SITE INSTRUCTION

SI A06

PROJECT : Forestside
PROJECT # : 1331.15
DATE : Aug. 18, 2021

Title: Revisions to plans as itemized.

ATTIMAR + PALLESCHI DRIVE		ONTARIO	
BRAMPTON			
PROJECT ARCHITECT:	B. GRAZIANI		
ASSISTANT DESIGNER:	R. LINCOLN		
DRAWN BY:	G. C.F. / C.M.B		
CHECKED BY:	D. BIASSE / G. COLANGELO		
PLOT DATE:	AUG. 18 2021		
JOB #F	139.1.15		
PI UNDERGROUND PLAN (OVERALL PLAN)			
		1:200	
		A211

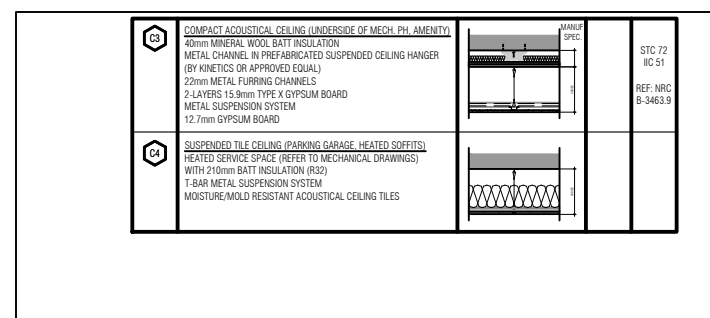
Reference:		Changes:
A211	Underground P1	Revise mechanical louvre size as per mechanical coordination.
A204	3 rd Floor Fire Separation	Add Fire rated enclosure on 3rd floor stairs as per mechanical coordination.
A303a-A303d	3 rd Floor Plans	Add Fire rated enclosure on 3rd floor stairs as per mechanical coordination.
A305a-A305d	Roof Plans	Add scupper locations to link areas as per mechanical coordination.
A504 and A505	Building Sections	Add Fire rated enclosure on 3rd floor stairs as per mechanical coordination.
